Project	IEEE 802.16 Broadband Wireless Access Working Group < http://ieee802.org/16 >	
Title	Action Item from Session #47: DRRM SS and DRRM BS text remedy	
Date Submitted	2007-03-15	
Source(s)	David Grandblaise Motorola Labs Parc Les Algorithmes Commune de Saint Aubin 91193 Gif sur Yvette, France	Voice: +33 (0)1 6935 2582 Fax: +33 (0)1 6935 4801 mailto: david.grandblaise@motorola.com
Re:	Working Group Letter Ballot #24a for IEEE P80216h/D2	
Abstract	It has been decided during session # 47 that DRRM should be removed and adapted in the draft. With respect to this, this contribution provides text remedies on DRRM SS and DRRM BS.	
Purpose	Action Item from Session #47: DRRM SS and DRRM BS text remedy	
Notice	This document has been prepared to assist IEEE 802.16. It is offered as a basis for discussion and is not binding on the contributing individual(s) or organization(s). The material in this document is subject to change in form and content after further study. The contributor(s) reserve(s) the right to add, amend or withdraw material contained herein.

Action Item from Session #47: DRRM SS and DRRM BS text remedy

David Grandblaise
Motorola

Figure h26—System Architecture

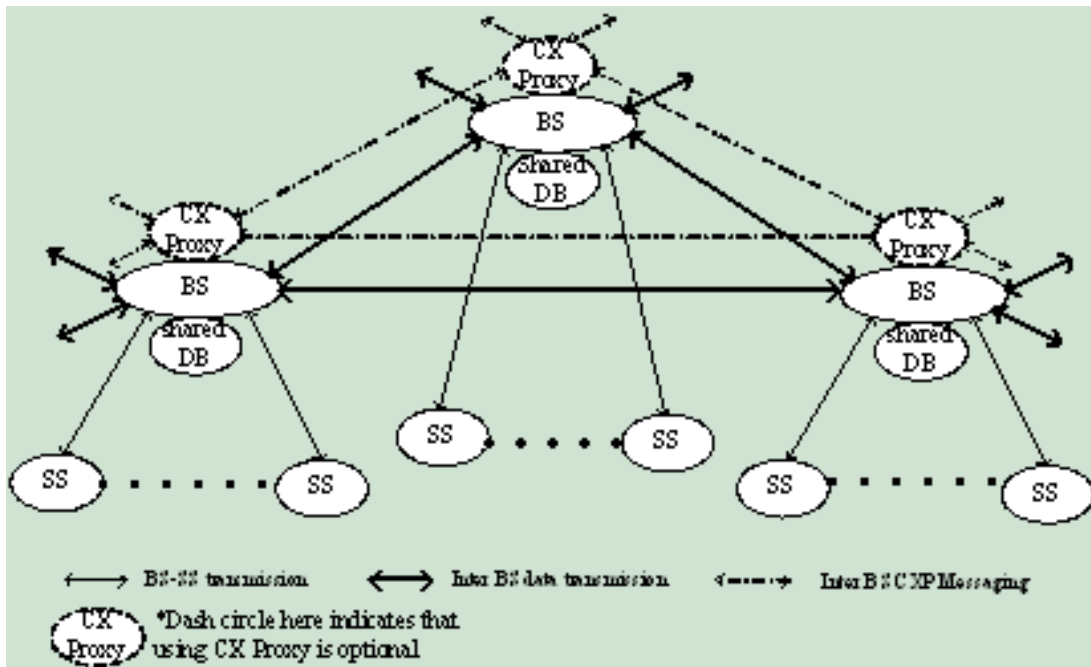
A subscriber station may include an instance of DRRM, adapted to SS functionality.

System Architecture illustrates the System Architecture.

1) Simply change "DRRM BS" and "DRRM SS" to "BS" and "SS" in figure h20.

2) and make it consistent with the text in the whole document.

Figure h27—

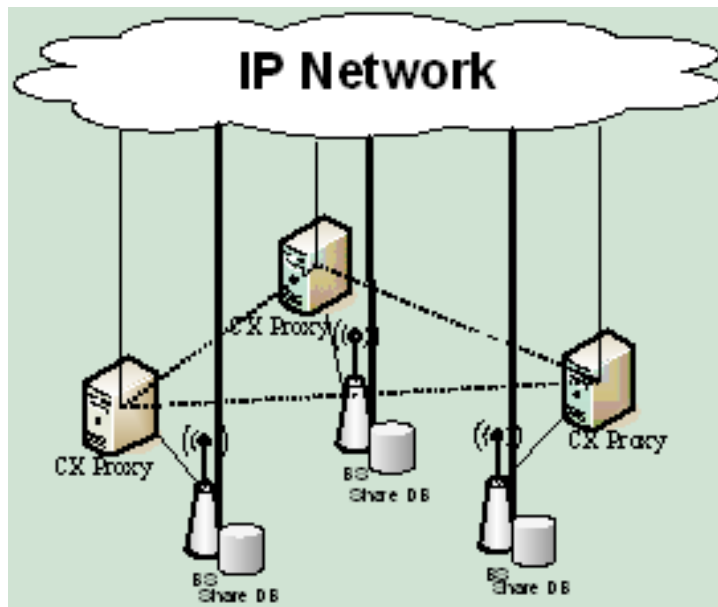
- Inter-system *messages*
 - o Base Station to/from Base Station
 - o The subscriber stations are used to forward the information contained in the signaling and messaging from the neighbor BS to its serving BS.
- Open access to the ~~DRRM~~Data Base (*optionally via a coexistence proxy*):
 - o To read the parameters of the hosting Base Station
 - o *To request changes of the hosting Base Station operating parameters.*
